AXOD/AXODE (AX4S) UPDATE HANDBOOK

INTRODUCTION

This updated version of the AXOD "Update Handbook" will also cover the changes that occurred in the 1991 model year, when electronic controls were adapted to the AXOD transaxle, making it an AXODE, and now called an AX4S transaxle. We have included the changes on the AX4S transaxle up through and including model year 2002.

Figure 60

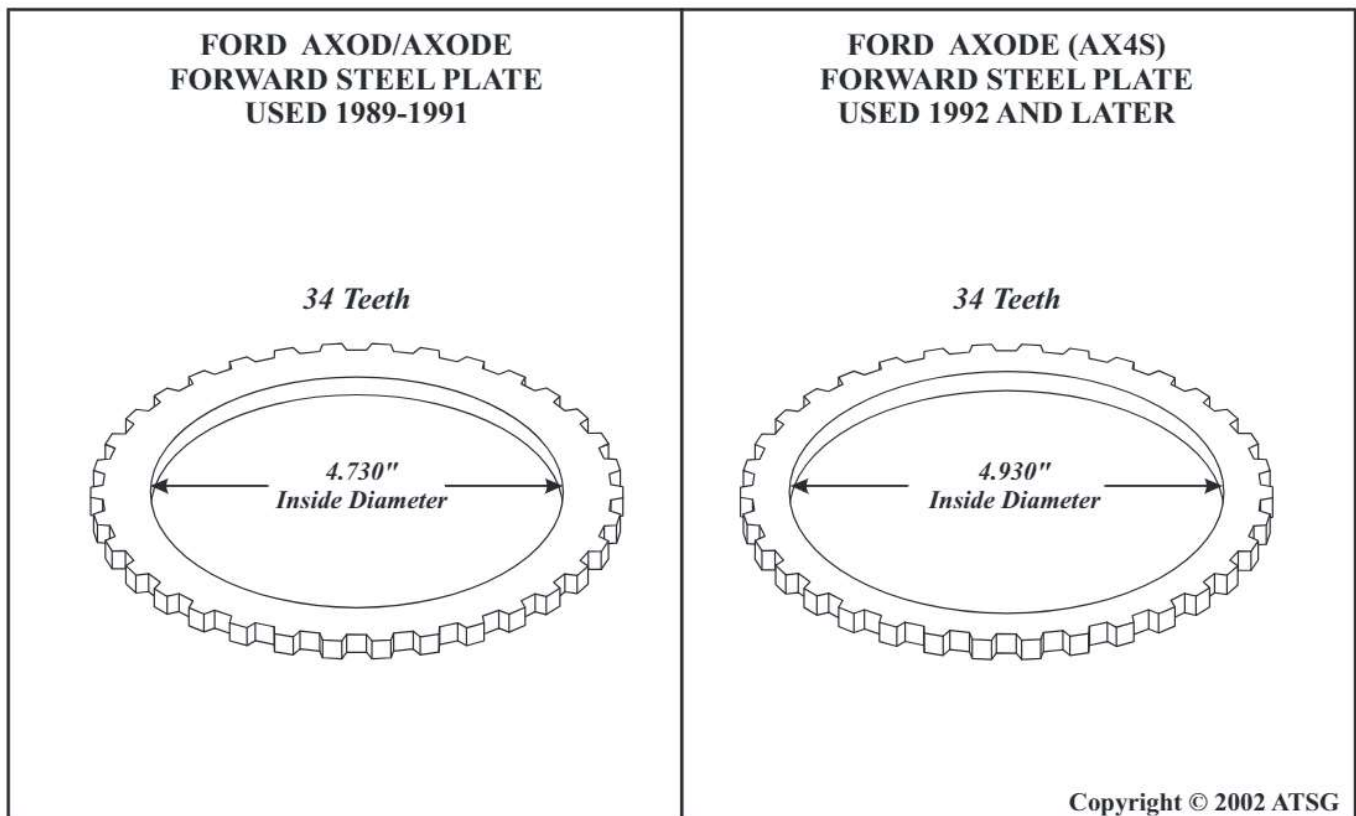
- (4) FORWARD CLUTCH PRESSURE PLATE - Has an increased inside diameter to 4.930" from the previous 4.730", to accommodate the increased diameter of the sprag outer race, as shown in Figure 60.

Figure 63

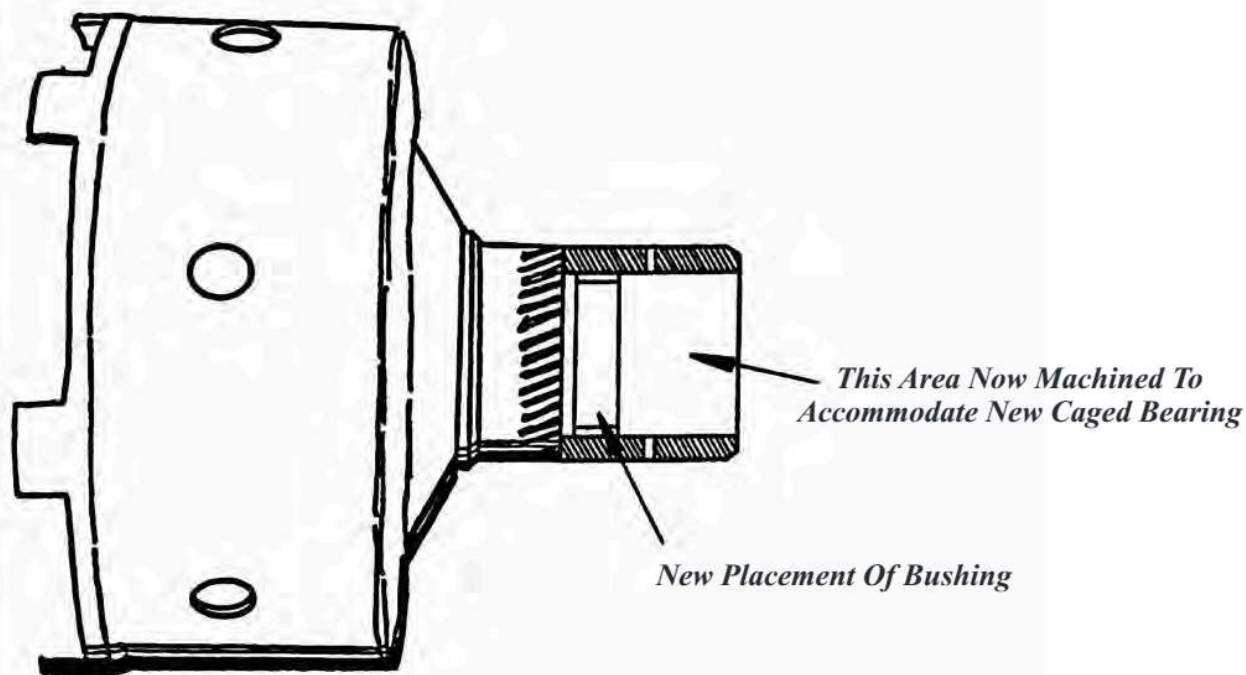
- (1) INPUT PLANETARY CARRIER - New caged needle Bearing added to the shaft on the Input Planetary Carrier, as shown in Figure 62.
- (2) SUN GEAR AND SHELL ASSEMBLY - Single bushing is now located in front of the lube holes in the sun gear, and the area behind is now machined to accommodate the new caged needle bearing, as shown in Figure 63.

Figure 64

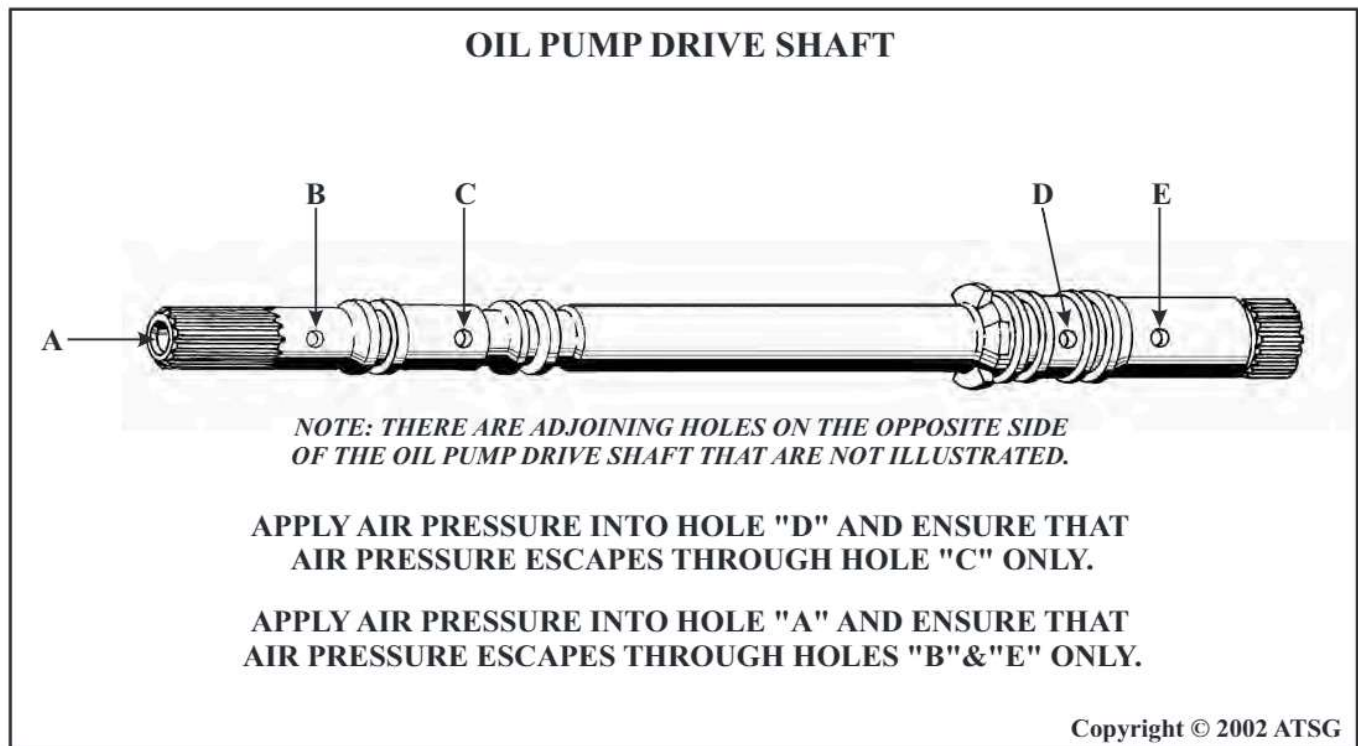
CORRECTION: Refer to Figure 64 to check the Oil Pump Drive Shaft, and clean or replace as necessary.

Figure 66

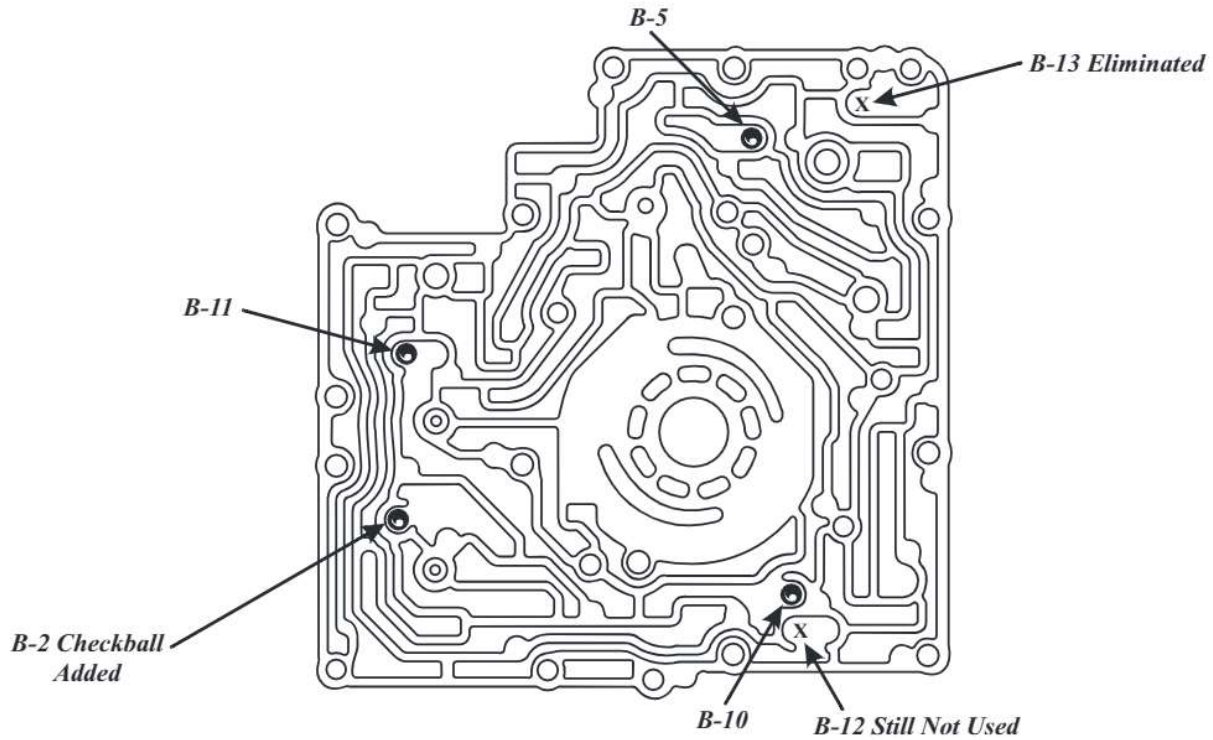
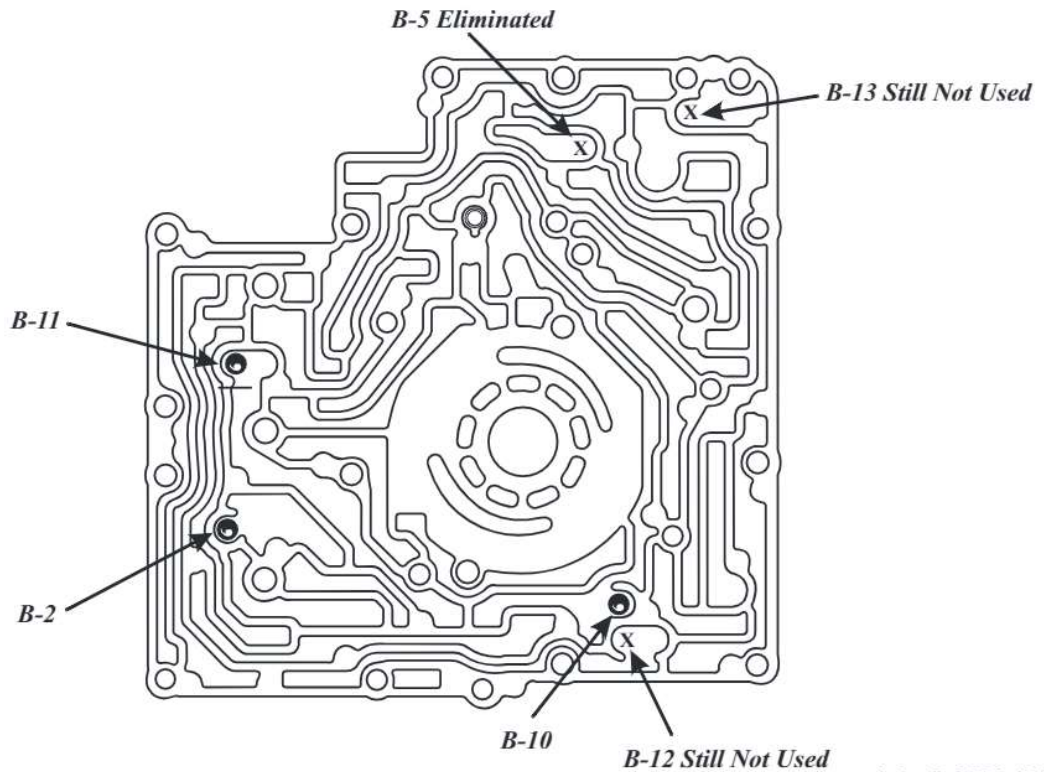
1992-1998 Only - Uses 4 checkballs but in different locations, as shown in Figure 66. B-13 checkball was eliminated and B-2 checkball was added.

1999-2002 Only - Uses 3 checkballs in the locations shown in Figure 66. B-5 checkball was eliminated.

Figure 67

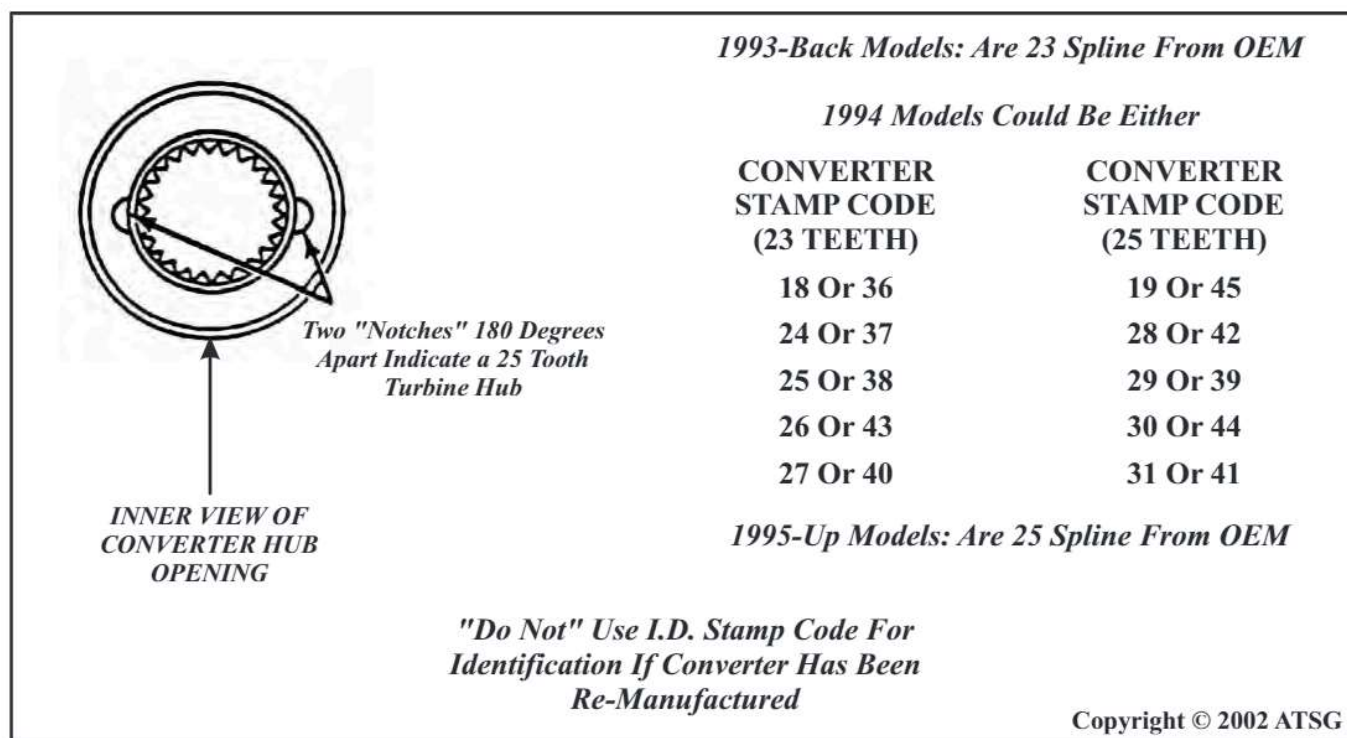
- (1) **TORQUE CONVERTER** - Converter turbine splines changed from 23 splines to 25 splines. To identify this change, the converter "Stamp Code" was changed. Refer to the chart found in Figure 67 for identification, if the converter has not been rebuilt.
- (2) **TURBINE SHAFT** - Splines changed from 23 splines to 25 splines. Count the number of splines on turbine shaft for positive identification.

Figure 75

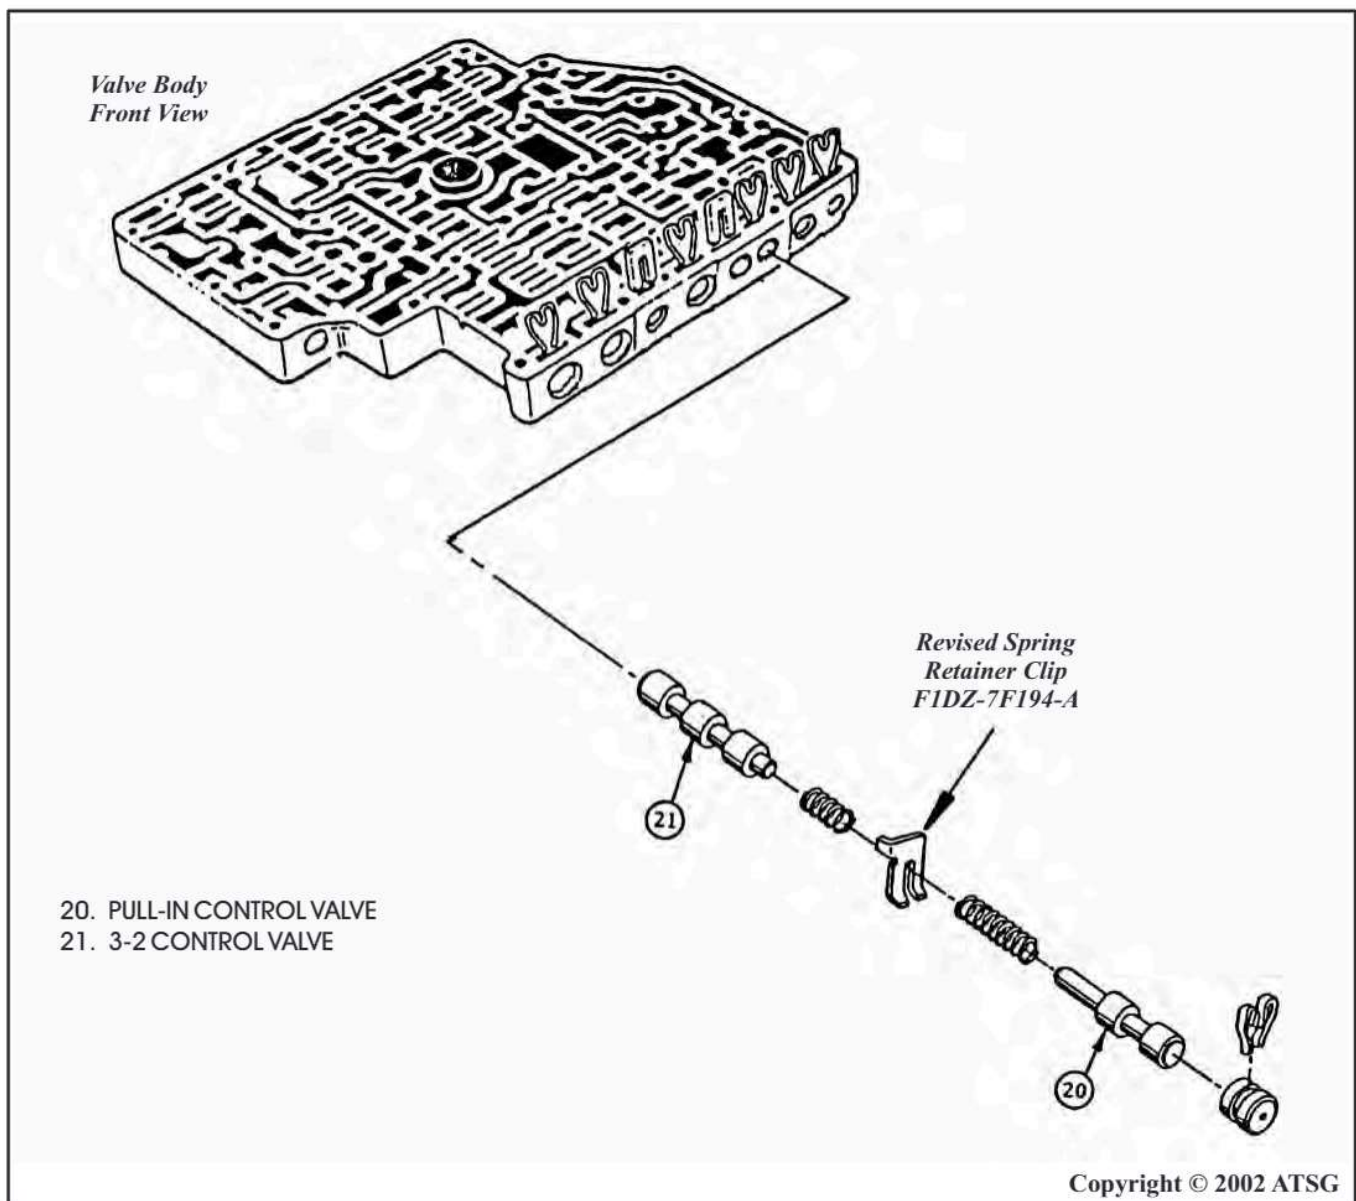
CAUSE: The cause may be, a broken spring retainer clip between the pull-in control valve spring and the 3-2 control valve spring, as shown in Figure 75.

CORRECTION: Replace the spring retainer clip with OEM part number F1DZ-7F194-A, as shown in Figure 75.

Figure 83

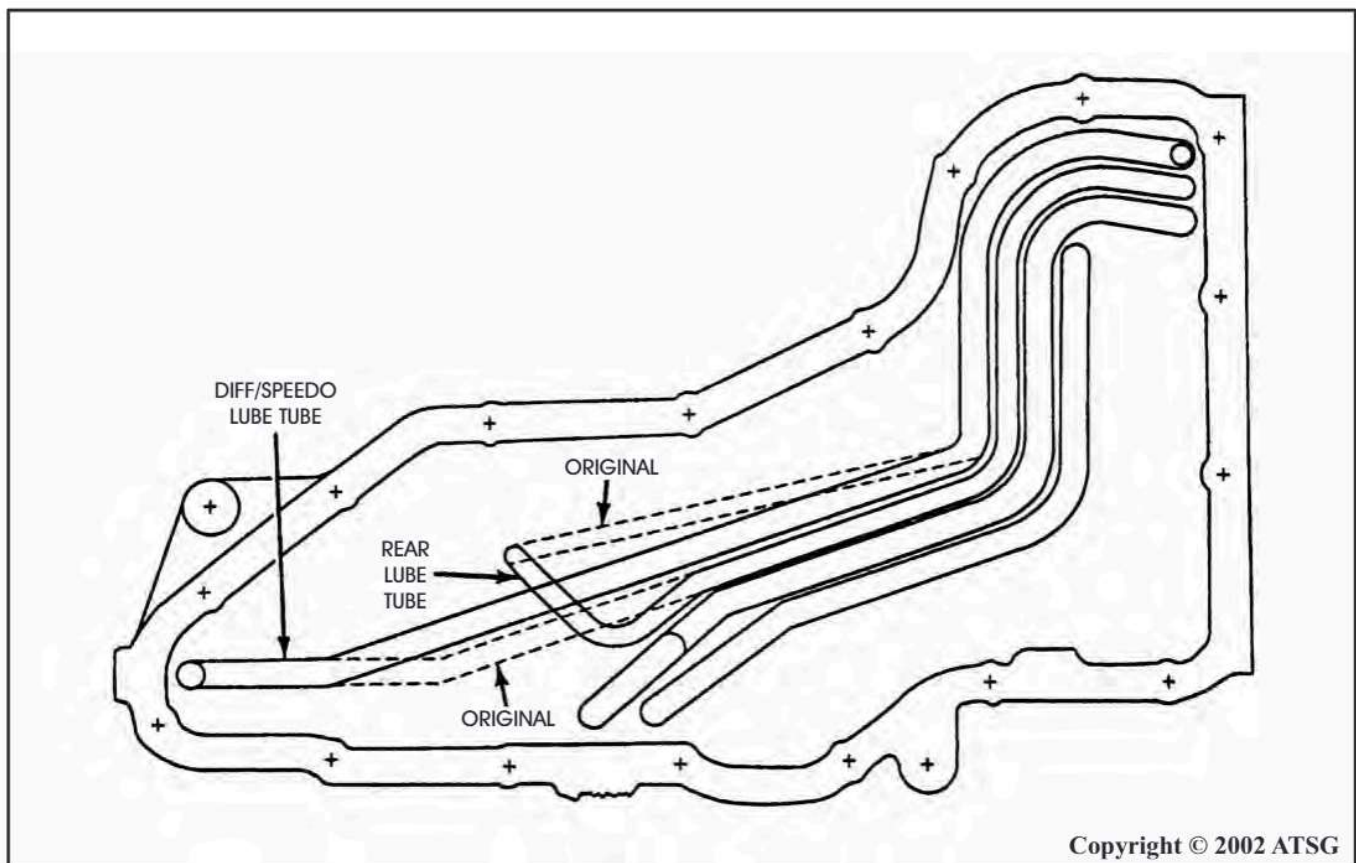
COMPLAINT: Front planetary and gear train failure with no visible root cause.

CAUSE: The cause may be, a limited volume of lube oil to the front planetary due to hydraulic control system demands.

CORRECTION: Install a new design "Cross-over" rear lube tube and a new design Differential/Speedo lube tube, that will increase the volume of lube oil to the front planetary system, as shown in Figure 83. This requires the rear lube tube to "Cross-over" the differential and speedo lube tube, as shown in Figure 83.

Figure 88

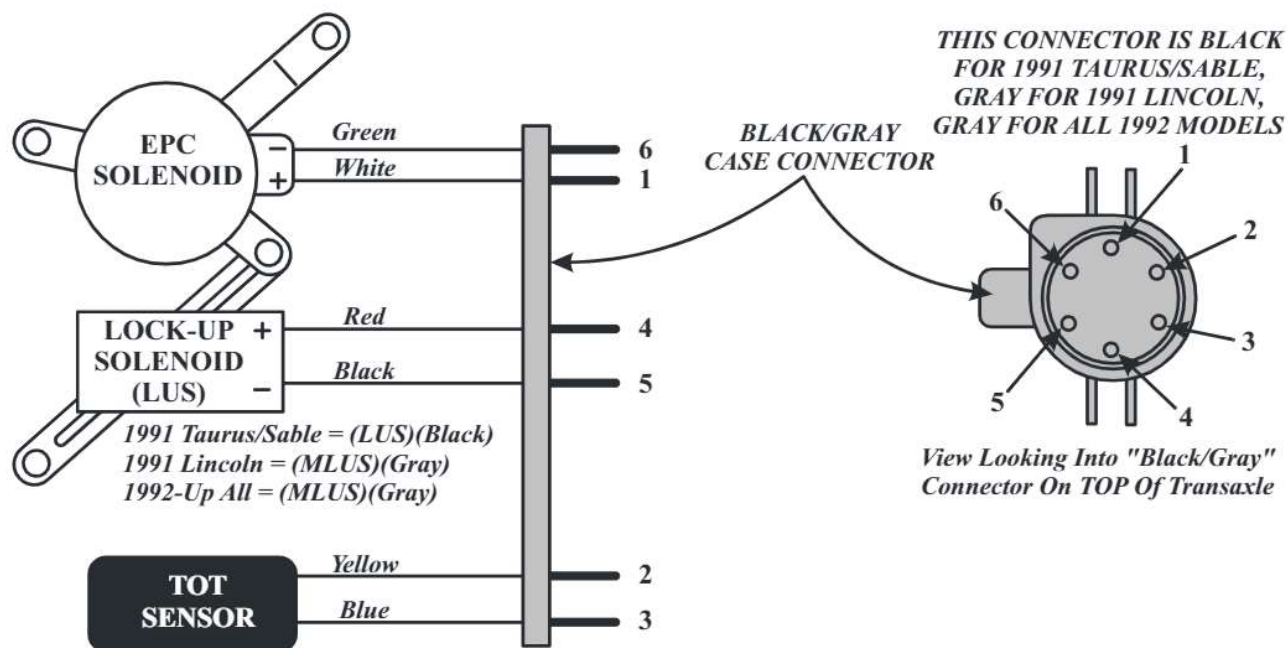
Wires for the Electronic Pressure Control solenoid are fed through pins 1 and 6 of the "Black/Gray" case connector, located on top of the transaxle (See Figure 88). Ohmmeter across terminals 1 and 6 should read 2.5-6.5 Ohms resistance.

Wires for the Modulated Lock-Up Solenoid (MLUS) are fed through pins 4 and 5 of the "Gray" case connector, located on top of the transaxle (See Figure 88). Ohmmeter across terminals 4 and 5 should read 0.75-2.0 Ohms resistance if you have MLUS. The Modulated Lock-Up Solenoid (MLUS) is found on the **Lincoln Only** for the 1991 model year. Taurus/Sable for 1991 are the regular Lock-Up Solenoid (LUS) that is described below. **All models for 1992 model year are MLUS.**

Wires for the Lock-Up Solenoid (LUS) are fed through pins 4 and 5 of the "Black" case connector, located on top of the transaxle (See Figure 88). Ohmmeter across terminals 4 and 5 should read 16-40 Ohms resistance if you have LUS. The Lock-Up Solenoid (LUS) is found on the **Taurus/Sable Only** for the 1991 model year. Lincoln for 1991 is the Modulated Lock-Up Solenoid (MLUS) that is described above. **All models for 1992 model year are MLUS.**

Wires for the Transaxle Oil Temperature (TOT) sensor are fed through pins 2 and 3 of the "Black/Gray" case connector, located on top of the transaxle (See Figure 88). Ohmmeter across terminals 2 and 3 should read the approximate resistance listed in the chart below. Resistance should decrease if transaxle is heated, and should increase if transaxle is allowed to cool. Oil pan that is warm to the touch is about 105°F-158°F.

Wires for Shift Solenoid 1 are fed through pins 5 and 6 of the "White" case connector, located on the side of transaxle (See Figure 88). Ohmmeter across terminals 5 and 6 should read 12-30 Ohms resistance.

Wires for Shift Solenoid 2 are fed through pins 1 and 2 of the "White" case connector, located on the side of transaxle (See Figure 88). Ohmmeter across terminals 1 and 2 should read 12-30 Ohms resistance.

Wires for Shift Solenoid 3 are fed through pins 3 and 4 of the "White" case connector, located on the side of transaxle (See Figure 88). Ohmmeter across terminals 3 and 4 should read 12-30 Ohms resistance.
